VERMONT YANKEE NUCLEAR POWER CORPORATION

Subject: Additional Information Submitted in Support of Request for
Exemptions - 10CFR Part 50, Appendix R

ADDITIONAL INFORMATION - Submitted in Support of the March 14, 1984 Request for Exemptions from 10CFR50 Appendix R: Items 4 and 6.

Figure 1

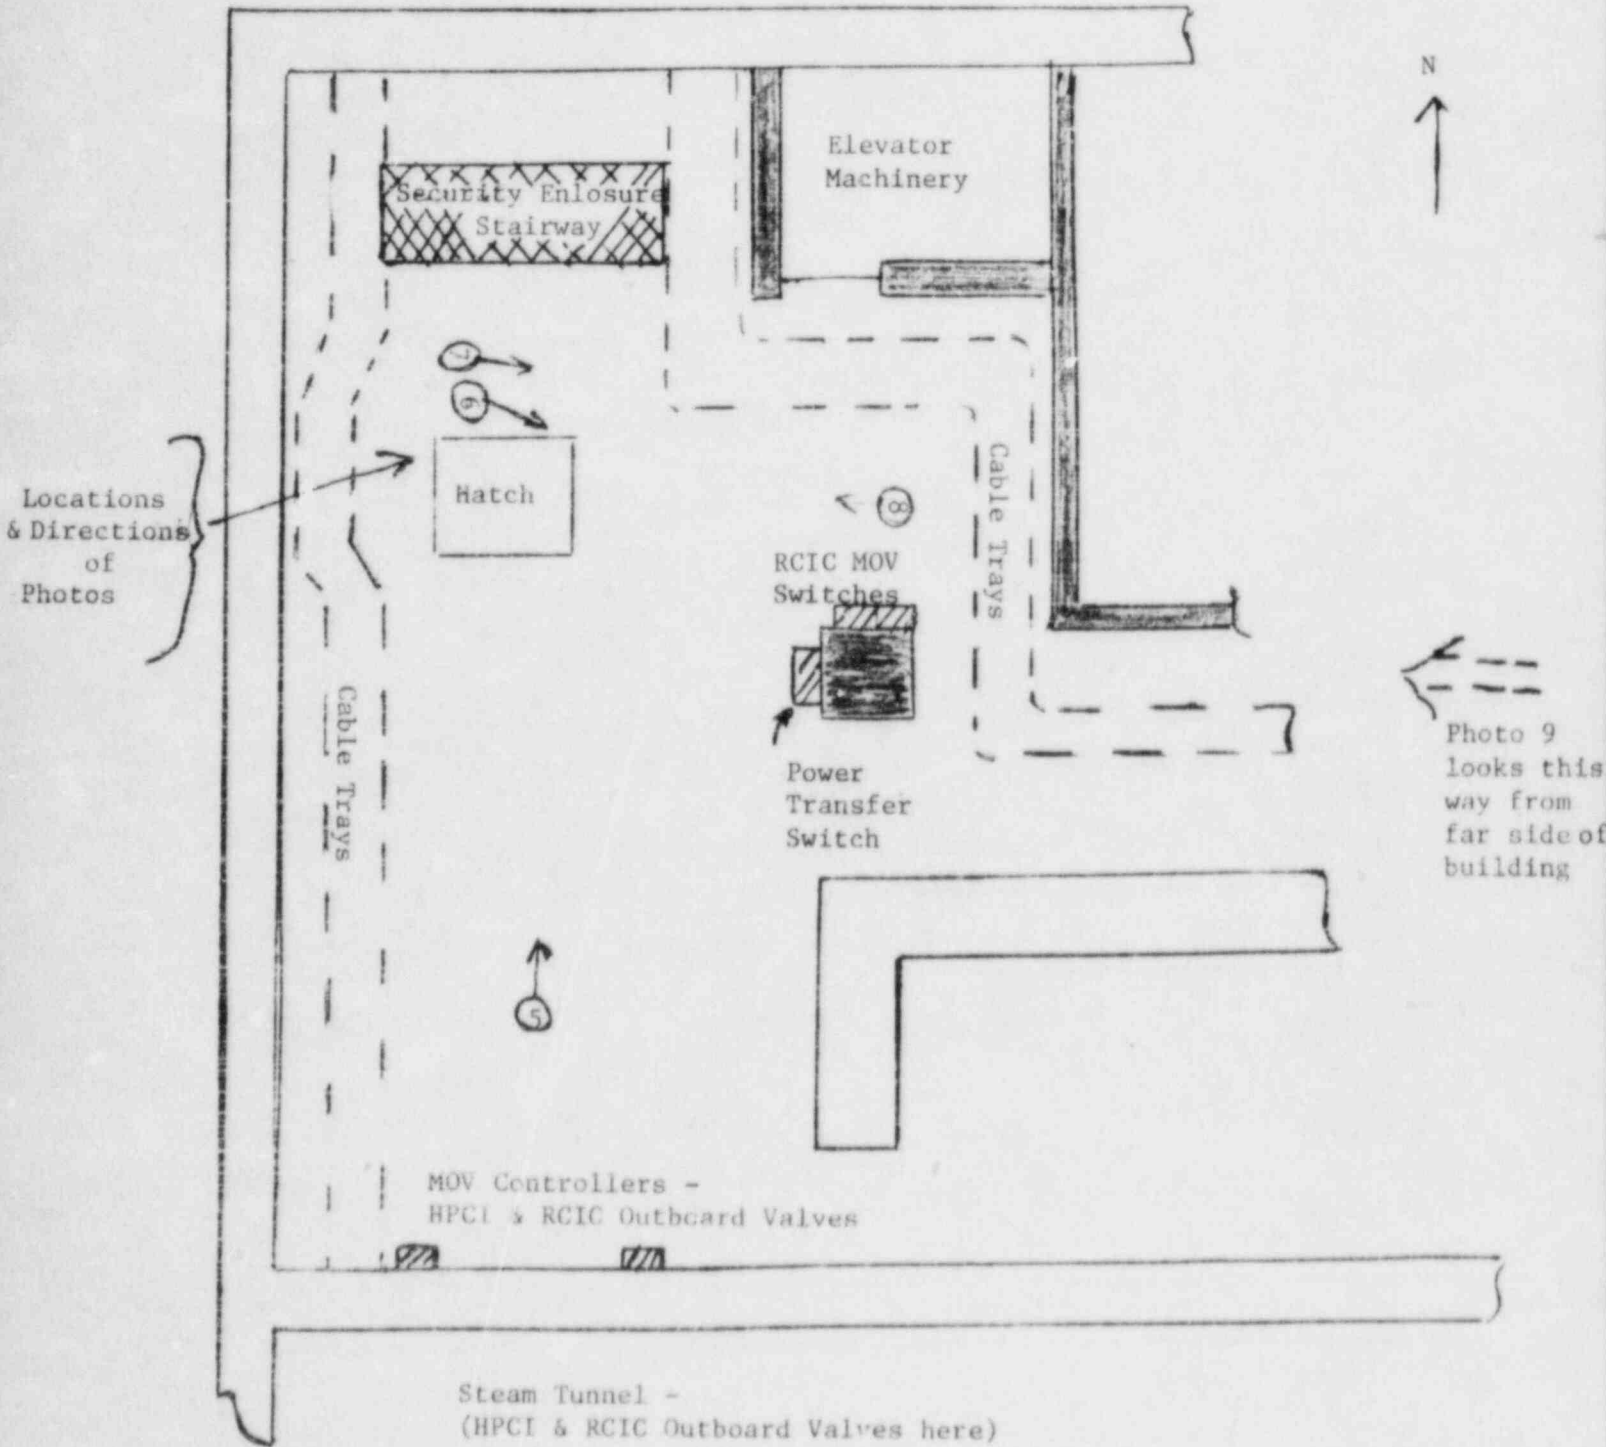
As shown in the enclosed sketch (Figure 1), the trays are currently separated by approximately 20 feet, then diverge further. This area between the trays is shown in Photo 5, previously submitted with Reference (b). Additionally, intervening combustibles are slight, as evidenced by Photos 7 and 8 of Reference (b), which show the banks of trays for each train.

On the column at the center of the enclosed sketch are a power transfer switch and control switches for the RCIC steam line inboard and outboard valves. The cable and switches are enclosed in conduit and control boxes minimizing the concern for this area as a source of intervening combustibles. The controller for the inboard valve is out of this area, located on MCC 89B in the northeast corner of the building. The outboard valve is accessible for manual operation in the steam tunnel, which is entered by a door on the south side, out of the fire area. Therefore, any potential hot shorts affecting these controls could be overcome by manual action outside the fire area.

HPCI and RCIC outboard steam line valve controllers are located on the south end of this area, on the north wall of the steam tunnel, as shown in the sketch, (no photo taken). The HPCI outboard valve is also available for manual operation in the steam tunnel. Thus, in the unlikely event of hot shorts closing any of these normally open steam line valves, they could be opened by the operator outside the fire area.

The floor at level 252 is mostly thick reinforced concrete. There is a bolted steel plate hatch for machinery access, and a stairway as shown in the sketch (Figure 1). The stairway is enclosed by a heavy steel plate security enclosure. Power cables in the room below, at floor elevation 232'. This is discussed in Exemption Request No. 1 of Reference (b). Since there will be suppression in the rooms above and below this floor, and the power cables are not in contact with the underside of the floor and not directly under the hatch, but about six feet below [see Photos 22 and 23 of Reference (b)], the probability of a fire on either side of this floor affecting equipment on the other side is extremely small.

Figure 2

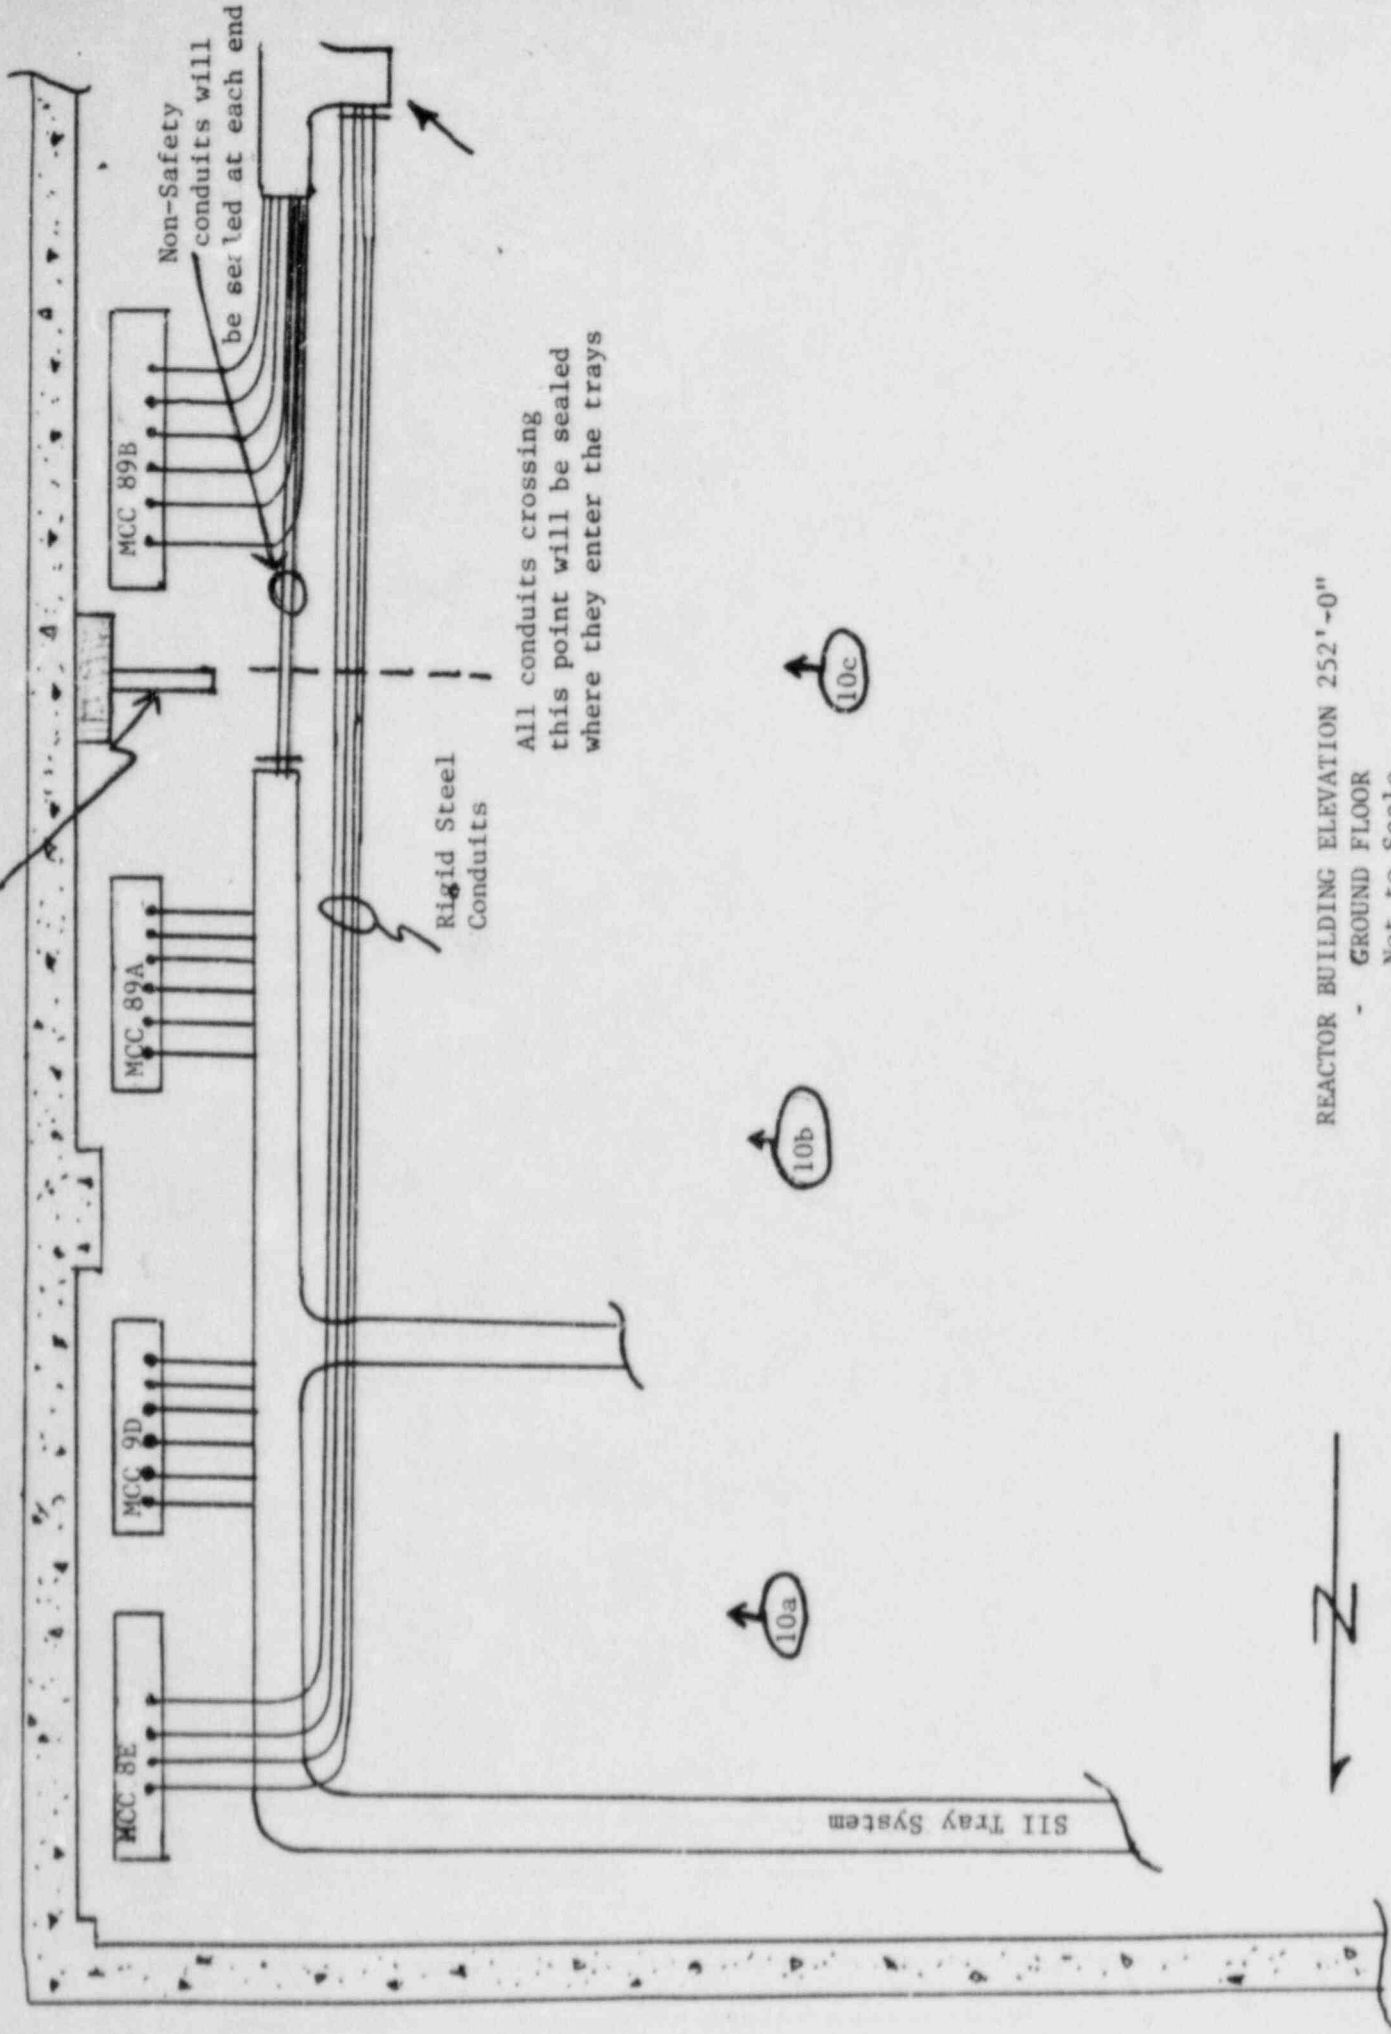
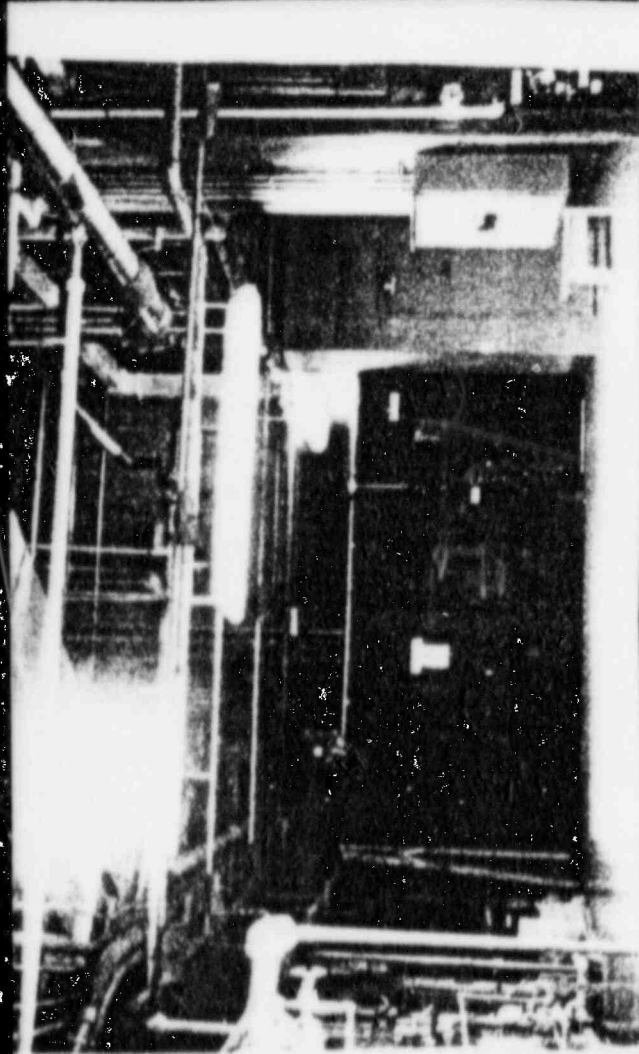
Additional information enclosed in support of this exemption request includes: a sketch (Figure 2) of the Reactor Building Elevation 252' Northeast Corner ground floor, which identifies the location of the modifications to be installed; and three photographs which illustrate the MCCs and cable trays in the northeast corner vicinity (These photos are views looking east and show the MCCs in question. These photos are identified on the enclosed sketch as Photo 10.a, 10.b, and 10.c, and provide an eastward view corresponding to the previously submitted Reference (b), Photo 10).

These MCCs contain control and power feeds for redundant AC motor-operated valves, some of which are located inside the inerted containment. There is approximately an 18-foot separation between the vital MCCs in question. The ceiling is approximately 27 feet high. There are two cable trays approximately 18 feet off the floor which run over MCCs 9D and 89A, and extend six feet toward MCC 89B. There are no other cable trays located between the MCCs. There are other cables installed in conduit in this overhead region. There are no other in situ combustibles either at the floor elevation or in the overhead region as addressed in the Fire Hazard Survey submitted on January 31, 1977.

We will install approved fire stops in all conduits that span the subject MCCs. These stops will be installed in those conduits which accept cables from the two cable trays that run part of the way between the MCCs. In addition, any other conduit that shares a common enclosure away from this area will also be fire stopped. With the installation of the above fire stops, a fire cannot propagate from the area of one MCC to the other MCC via cable nor can a fire concurrently propagate from another outside area to both of the MCCs.

We will also install a radiant heat shield between MCC 89A and 89B. This shield will extend up approximately 14 feet and at least four feet out from the wall as shown in Figure 2.

Radiant Heat Shield

Non-Safety conduits will be sealed at each end

All conduits crossing this point will be sealed where they enter the trays
